File ref: **SSD-78247462**

12 June 2026

RE: SUBJECT CANYONLEIGH BESS PROJECT SSD-78247462
962 Canyonleigh Road, Brayton

TABLE 5-2 PREDICTED ONSITE CONSTRUCTION NOISE LEVELS

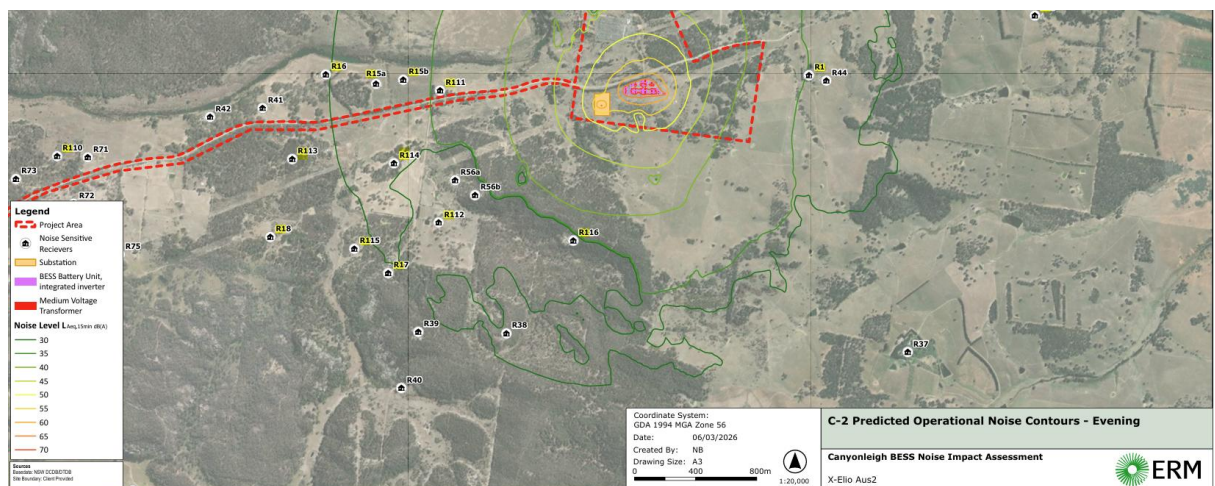
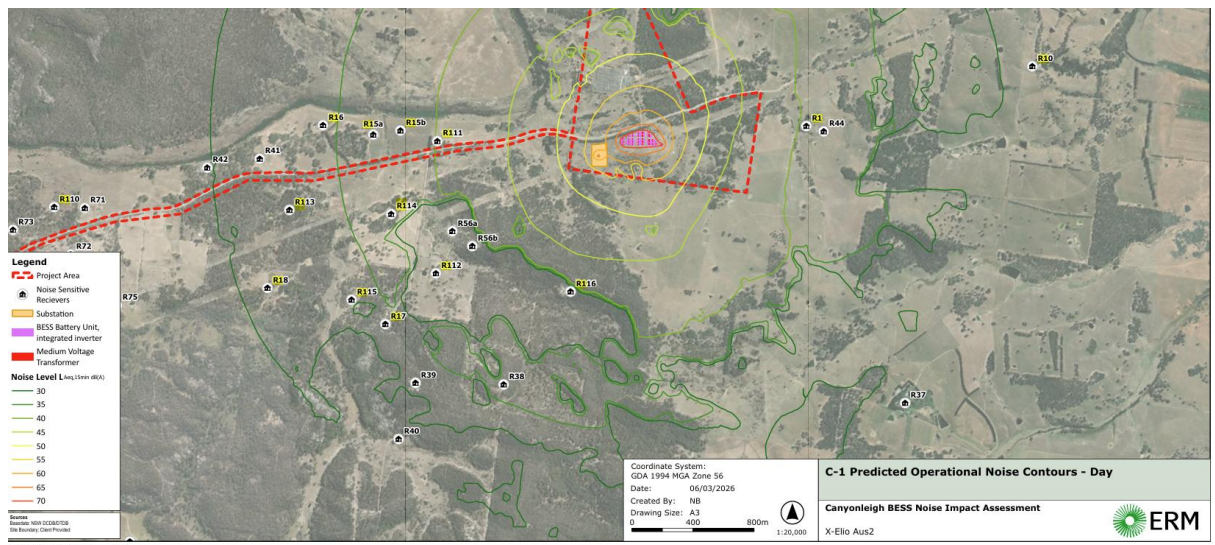
- We are particularly concerned with regards to noise and vibration, because the farm is the most directly impacted during construction. The property is identified a Noise Sensitive Receiver R1 and R44 (Refer to extract Table 5-2 below).

The construction noise assessment concluded that the ICNG 'noise affected' management level is exceeded at 2 NSRs (R1 and R44) for the site preparation and establishment construction scenario (CON 1), 3 NSRs (R1, R44 and R111) for the delivery of infrastructure construction scenario (CON 2), and 3 NSRs (R1, R44 and R111) for the general construction of infrastructure construction scenario (CON 3).

Figure 1: Existing Marulan Transgrid Substation

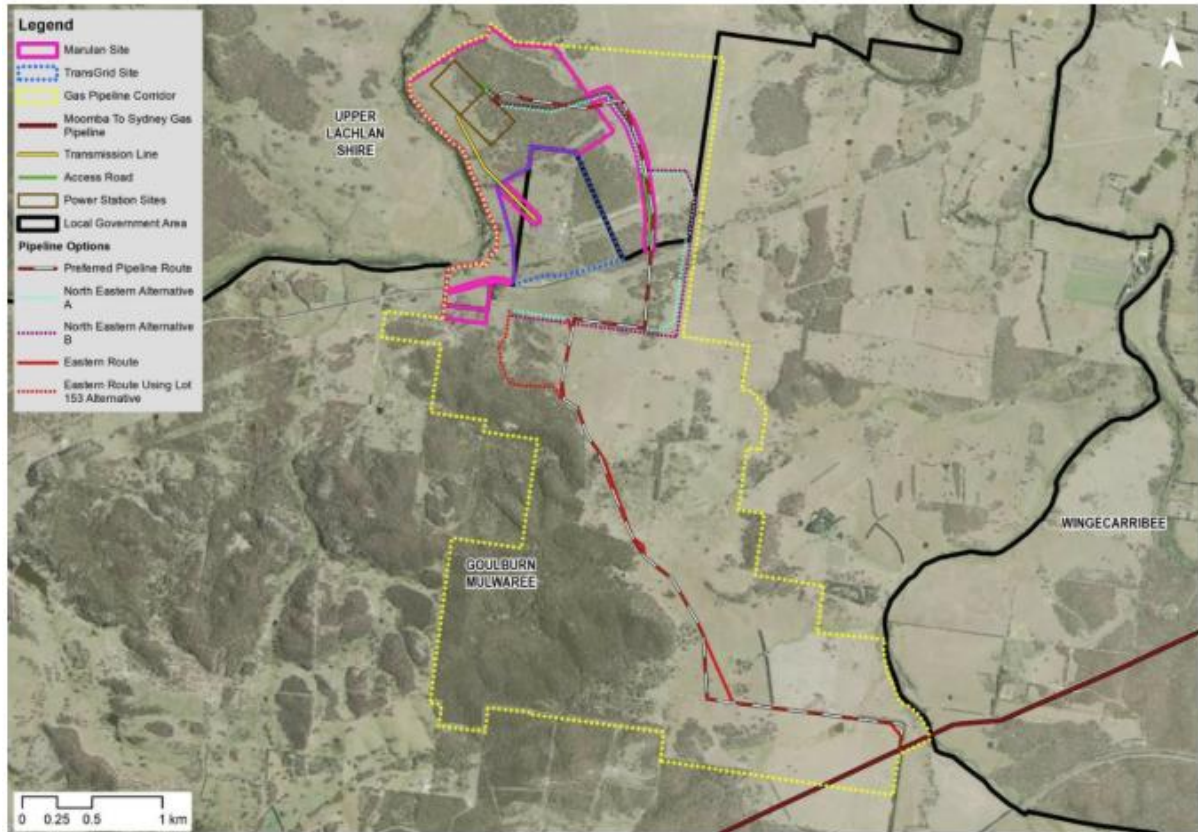
- The current and existing proposals in the immediate locality consist of:
 - o the nearby existing Transgrid Marulan Substation with capacity of 480MVA, refer to Figure 1 attached;
